NAVAL ASSESSMENT AND CONTROL
OF INSTALLATION POLLUTANTS
REVIEW WORKSHOP

NAS-JACKSONVILLE

VERIFICATION STUDY
CHARACTERIZATION STUDY

April 29, 1986

SITE NOS. 11, 12, 14, 15, 16. NARF AREA

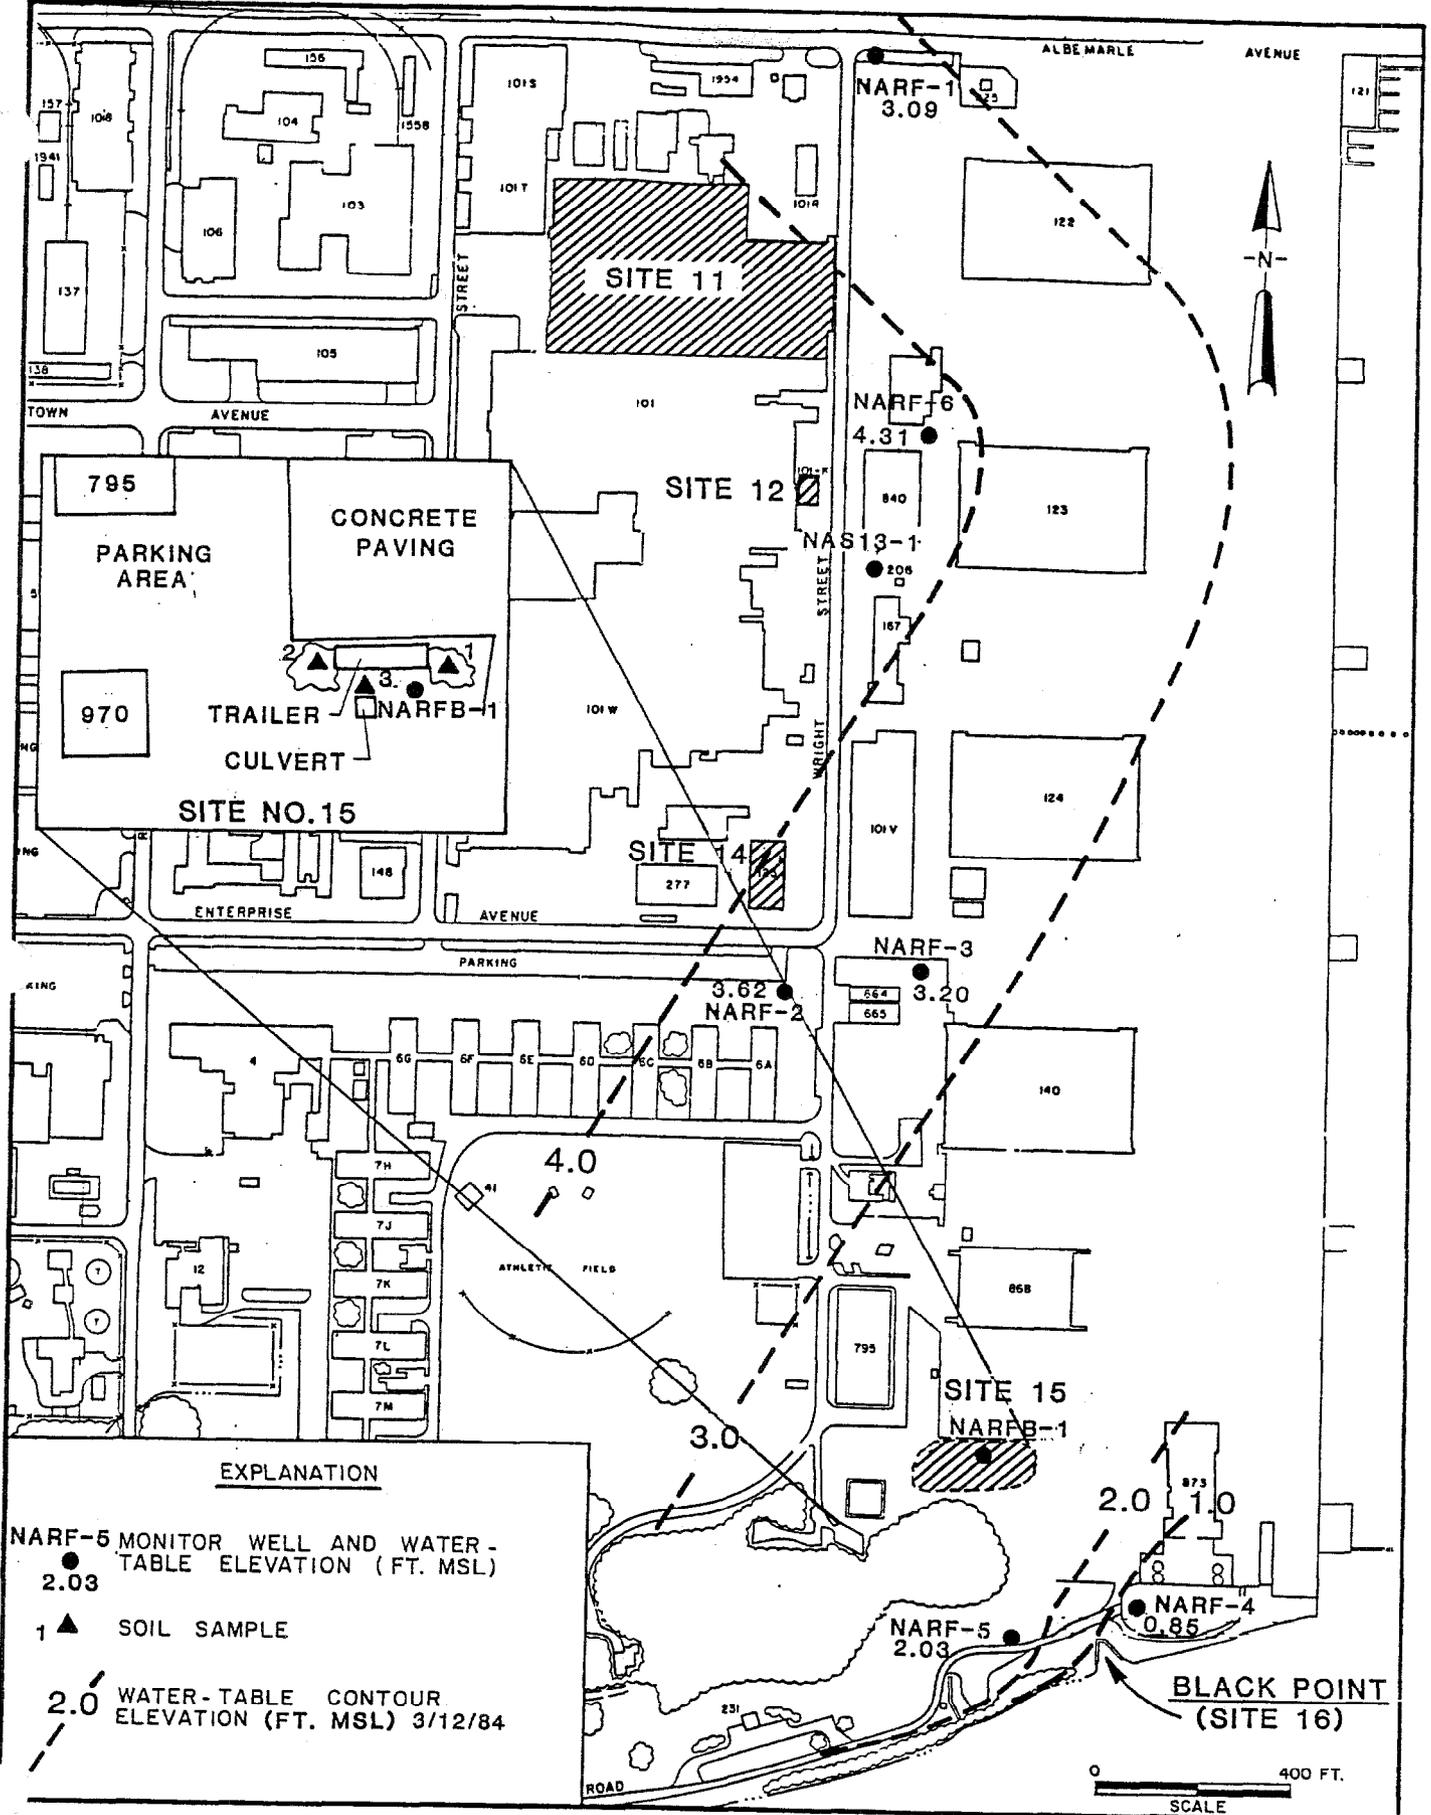
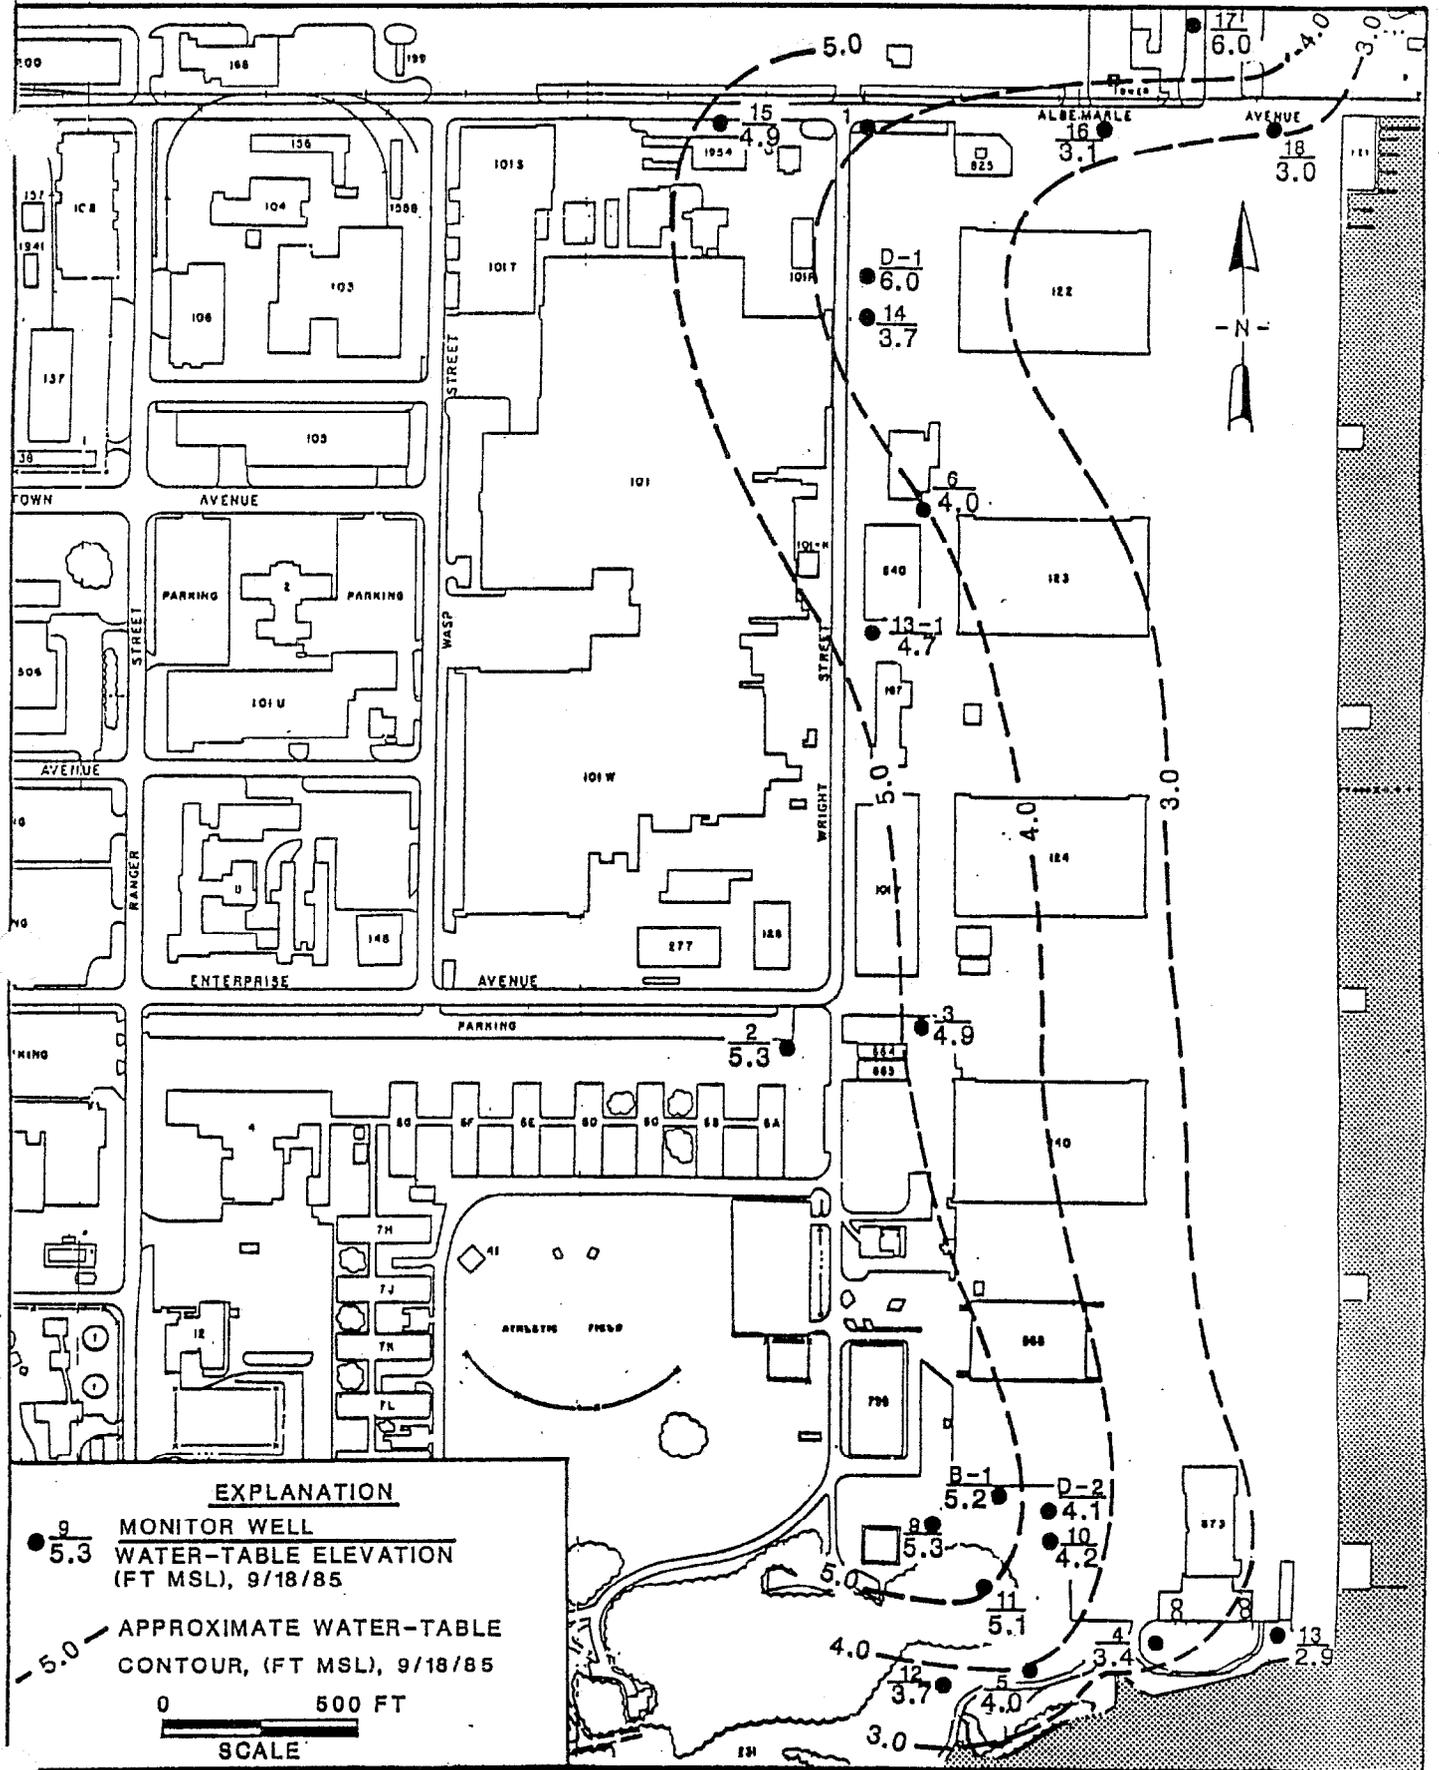
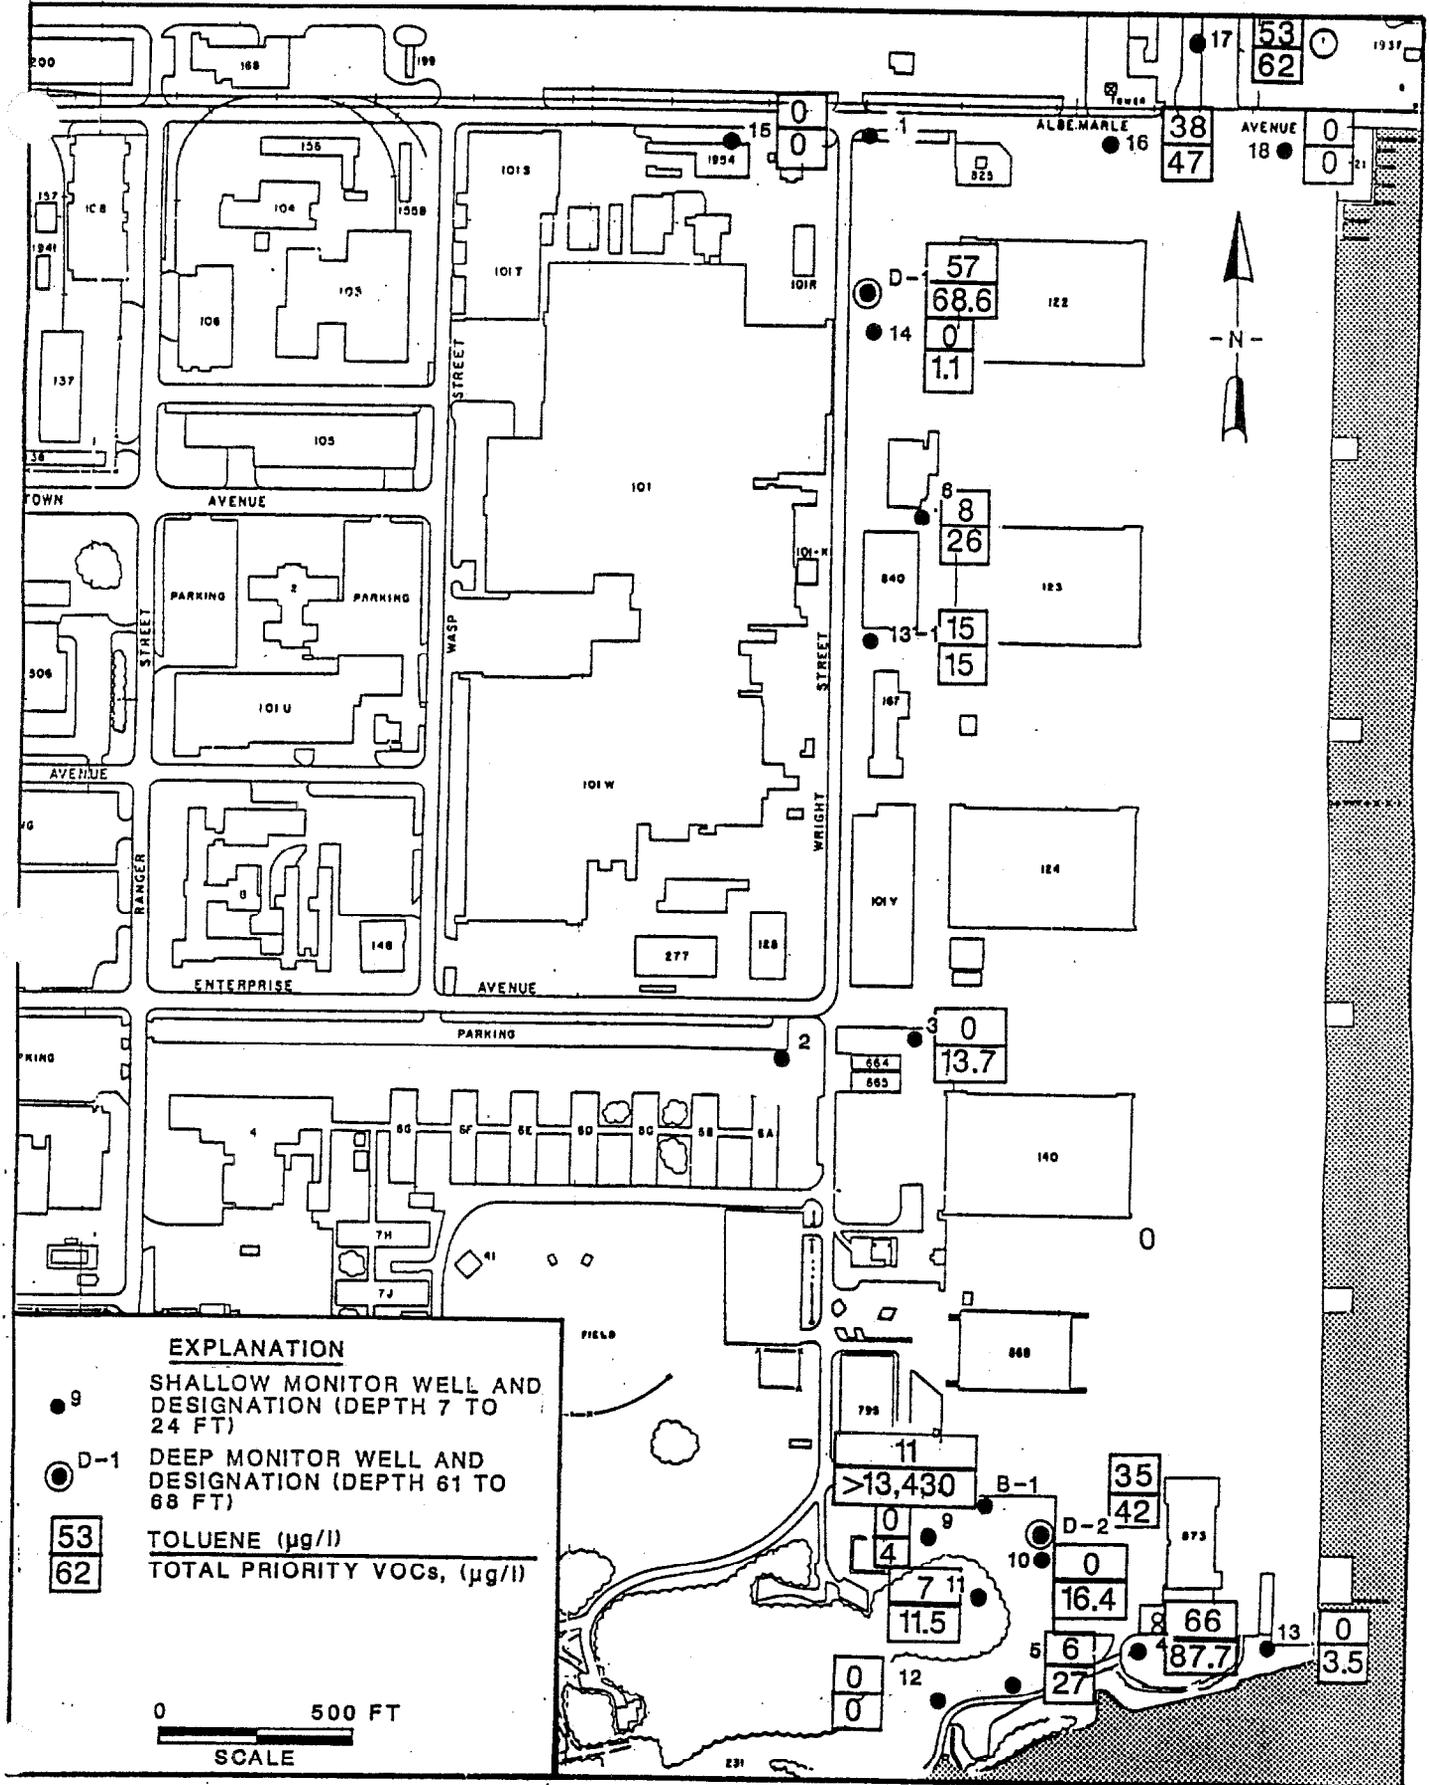
Crane
Mr ~~Clark~~ *Crane* thinks risk assessed on North end is OK. South end D1 needs corrective action.

Mr Crane would like to test specific conductance.
Place NARF as a whole under risk assessment.

SITE NO. 17. GLASS BEAD WASTE PILE

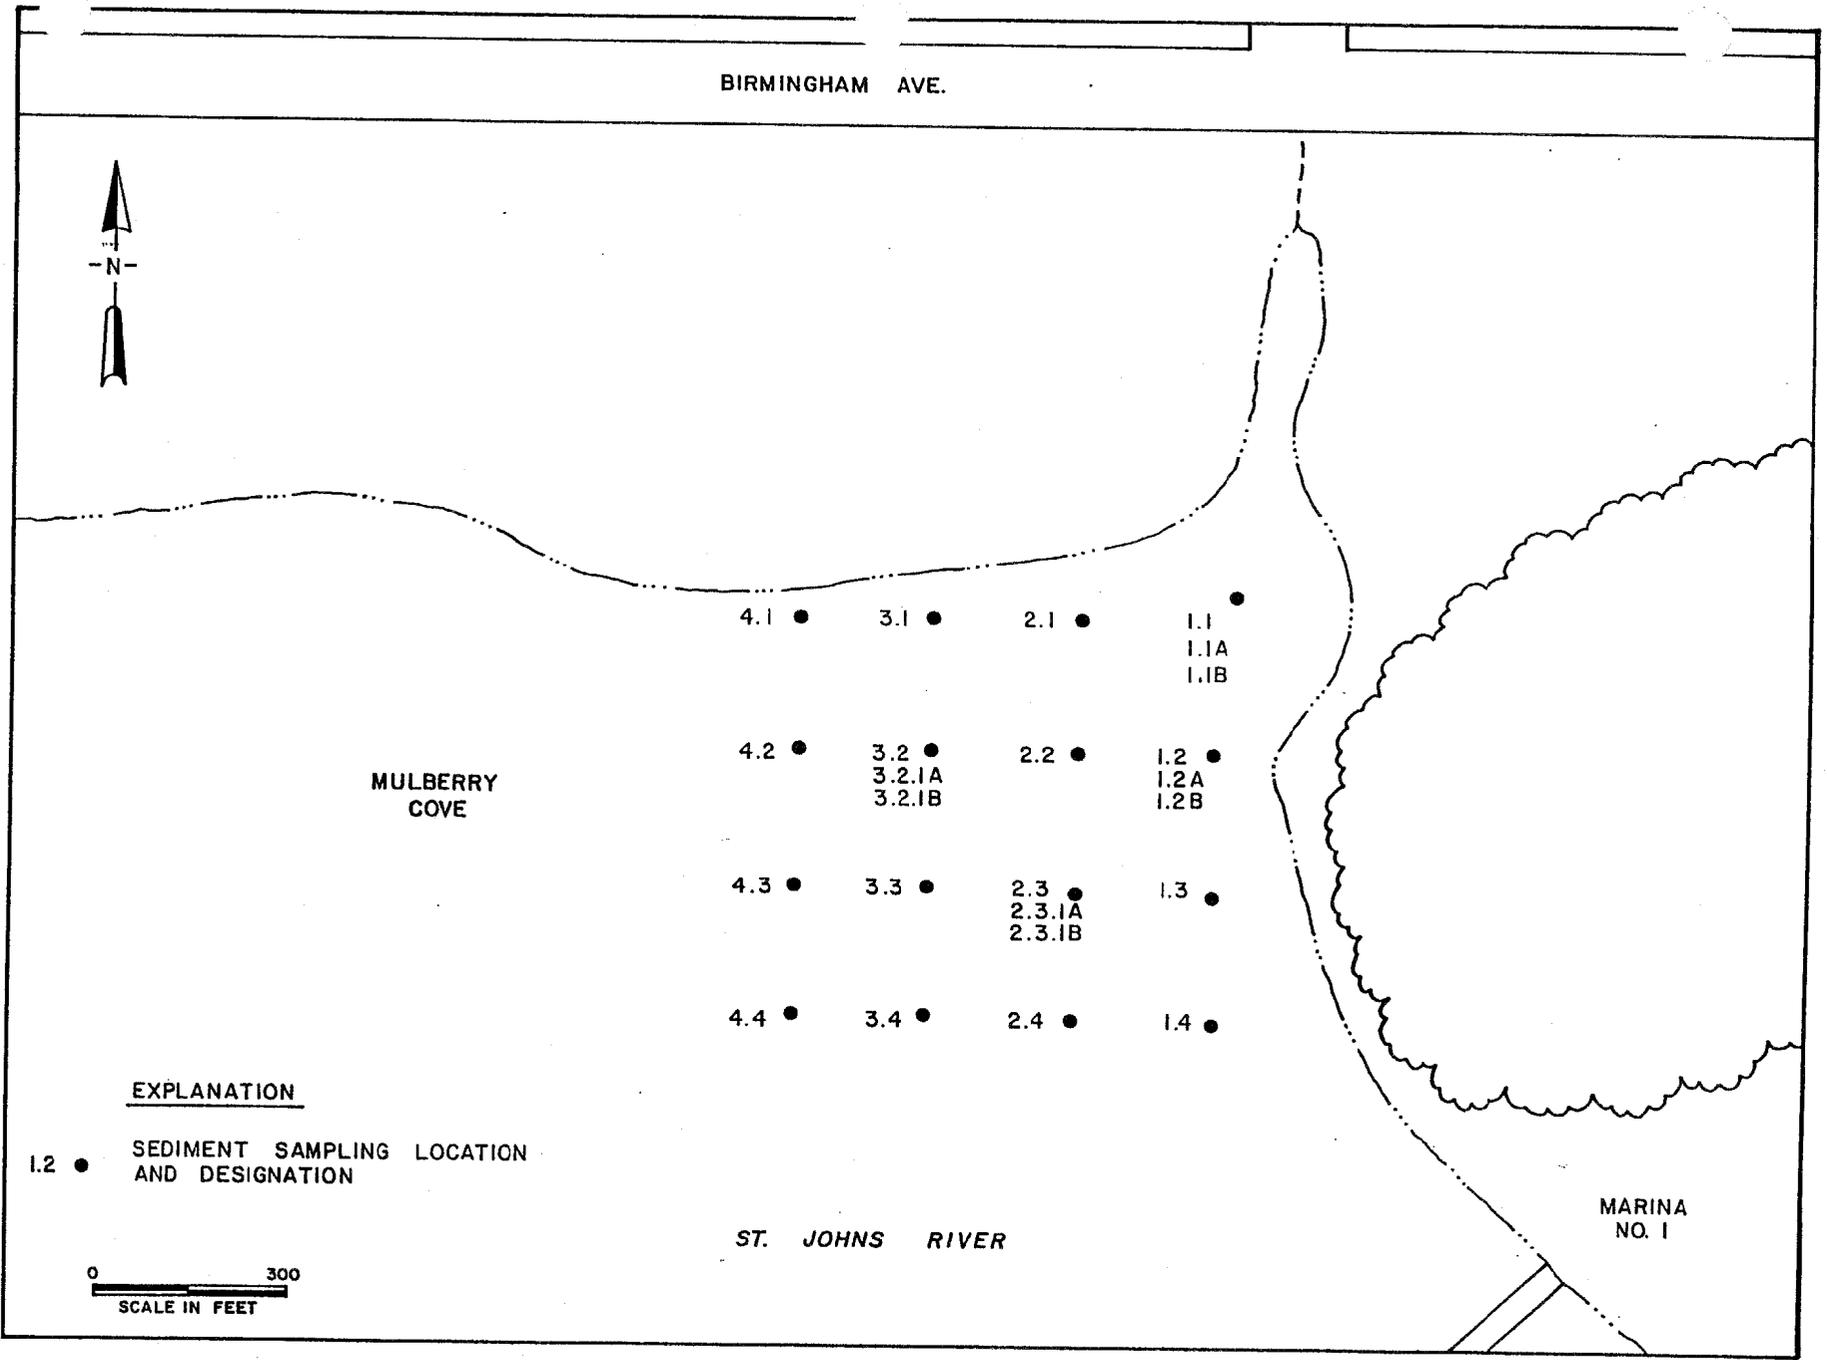
wayne mathis says drop it EPA.
